## REGIONAL REVIEW NOTIFICATION

DATE: August 14, 2018 ARC REVIEW CODE: R1808131

Name of Proposal: Founders Studio & Founders Square (DRI 2830)

# FOUNDERS STUDIO AND FOUNDERS SQUARE DRI # 2830 Town of Tyrone ARC Natural Resources Group Review Comments

CONCEPTUAL PLANS
FOR
FOUNDERS STUDIO
AND FOUNDERS SQUARE

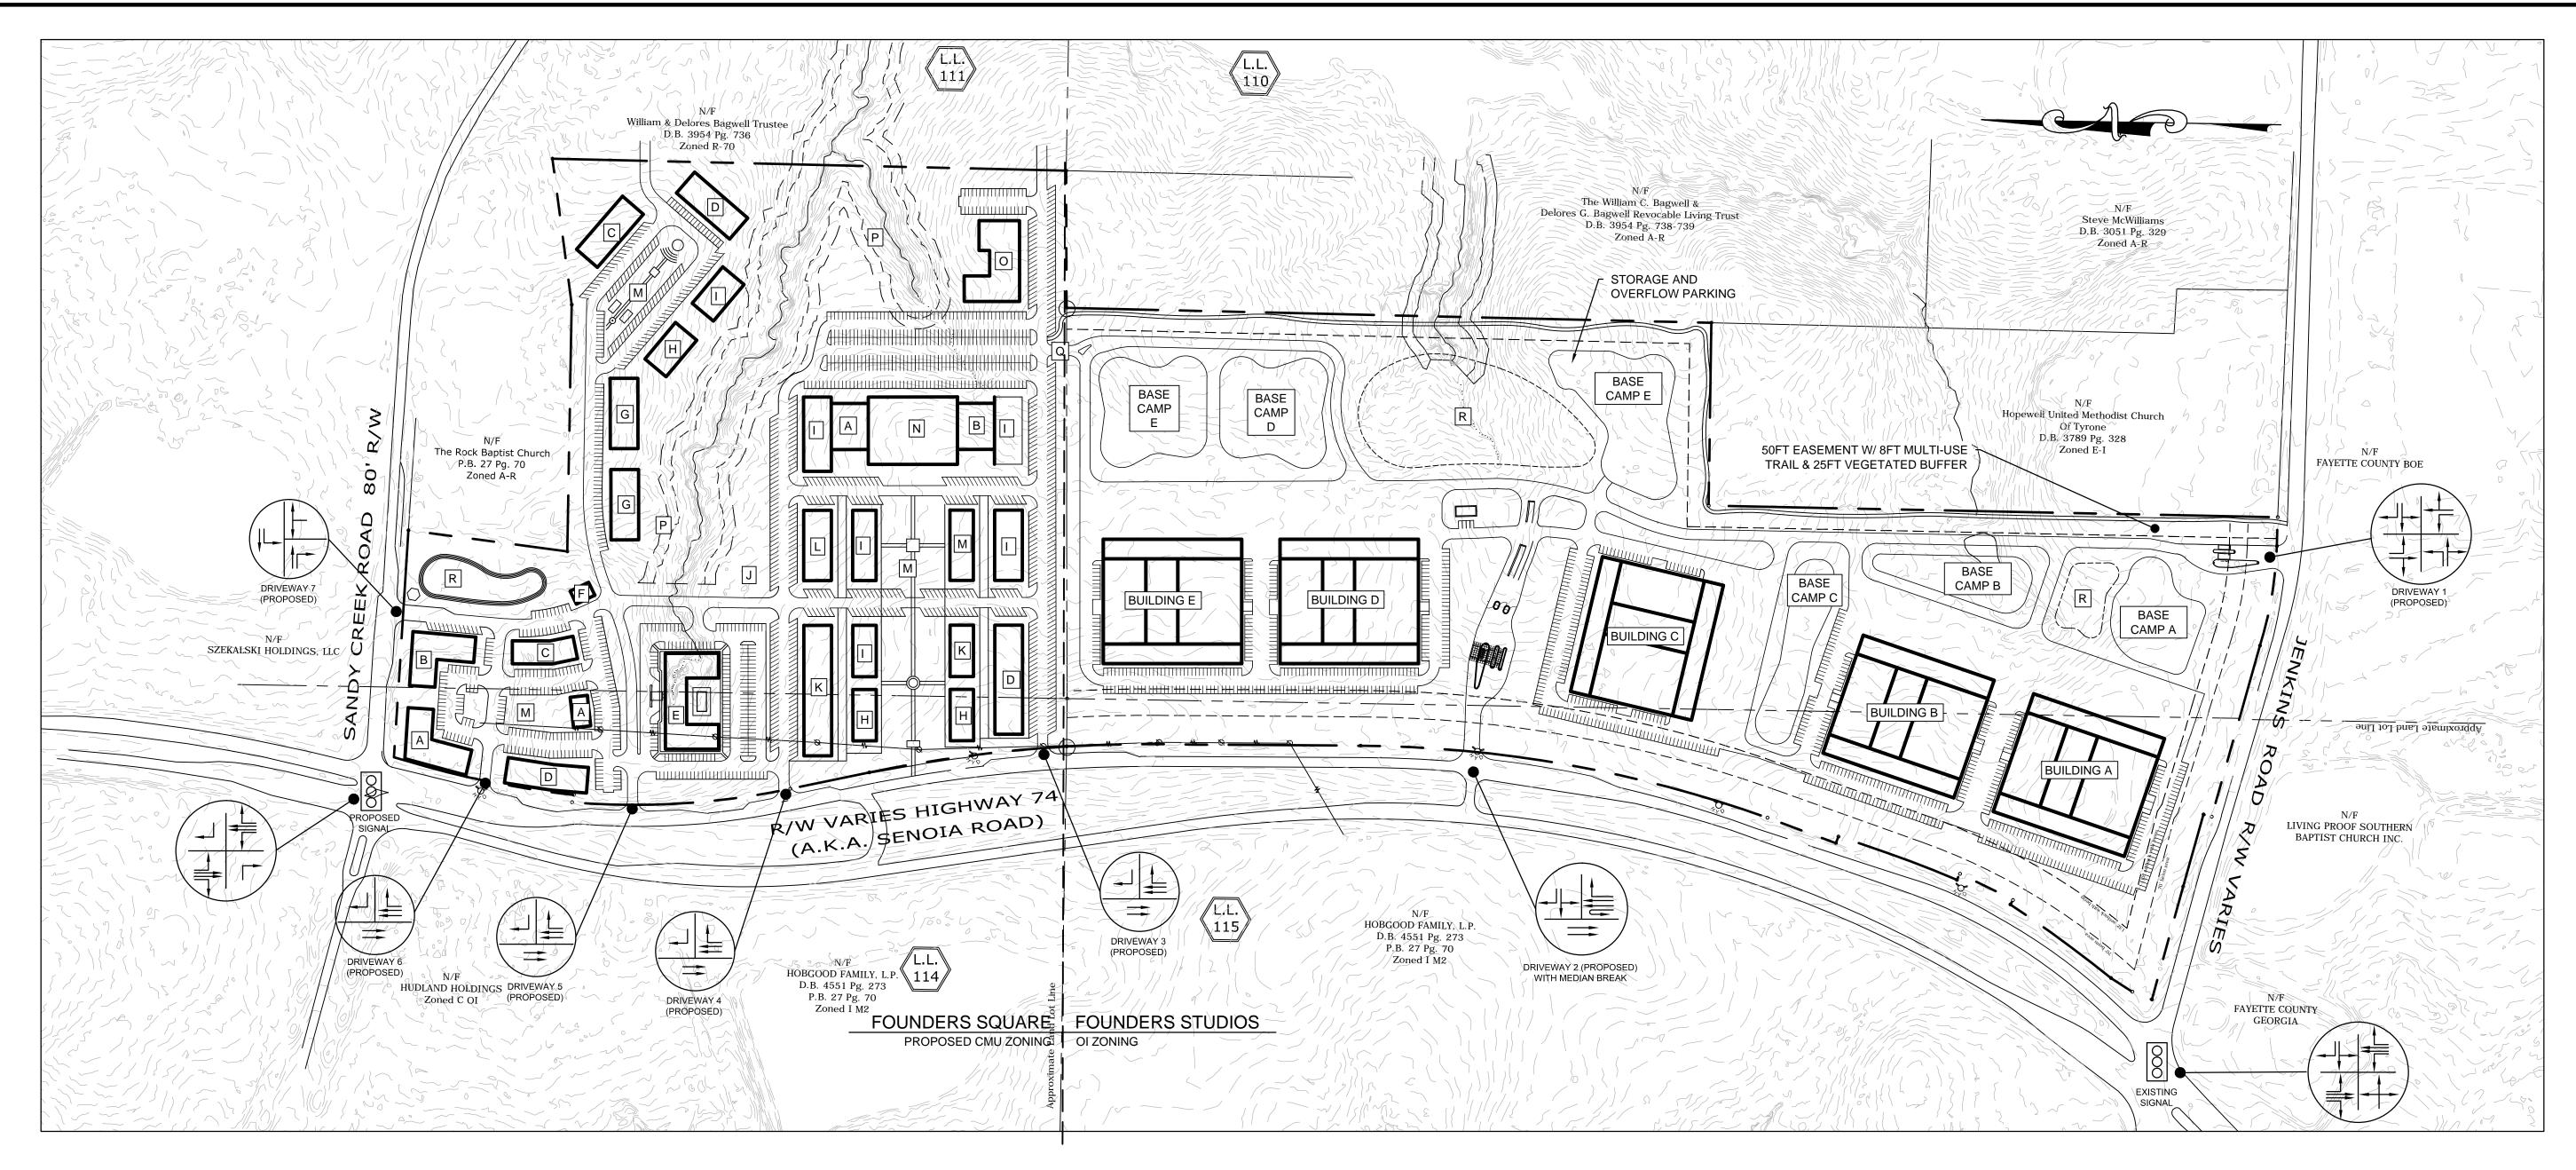
To capitalize on this potential, care should be taken to ensure that the development promotes an interconnected, functional, clearly marked and comfortable pedestrian experience on all streets, paths and parking areas. This is particularly important in terms of connections between the two sides of the site, which are oriented differently, for different user groups. Given site security needs for film studios, the studio component is naturally more self-contained and inward-facing. There is one gated connection between the studio and mixed-use components, for vehicles and pedestrians, near the rear (east side) of the site. This location is close to some of the retail/restaurant space and what appear to be upper-floor residential lofts, around the central park area. However, it is a considerable distance from the retail/restaurant node near the northwest corner of the site fronting SR 74 and Sandy Creek Road – as well as from the residential cluster in the northeast corner of the site, which is separated by a creek. The development team should explore providing another, potentially pedestrian-only, connection between the studio and mixed-use components closer to the front (west/SR 74 side) of the development. A potential

location could be the north side of Studio Building E, in alignment with the north-south roadway bisecting the central park area. This arrangement would offer studio workers additional and more direct access to pre- and post-work activities and needs (meals, shopping, entertainment, etc.) without adding car trips to the area road network. The development team is also encouraged to ensure that end-of-trip facilities (bicycle racks, etc.) are provided for residents, workers and visitors at key locations throughout the site.

The USGS coverage for the project area does show one intermittent stream (dashed blue line) that extends a short distance into the property on its eastern side near Jenkins Road. It appears to be the stream shown near the area noted as "Base Camp B" on the submitted site plan. No buffers are shown along that stream. The submitted site plan shows two other streams along the eastern edge of the property. The site plan shows a 50-foot undisturbed buffer and additional 25-foot impervious setback on both of these streams, consistent with the Town's Stream Buffer Ordinance. The Town will need to determine if its ordinance also applies to the intermittent stream at the southern end of the property. All of these streams, as well as any other waters of the state on this property are also be subject to the State 25-foot Sediment and Erosion Control Buffer.
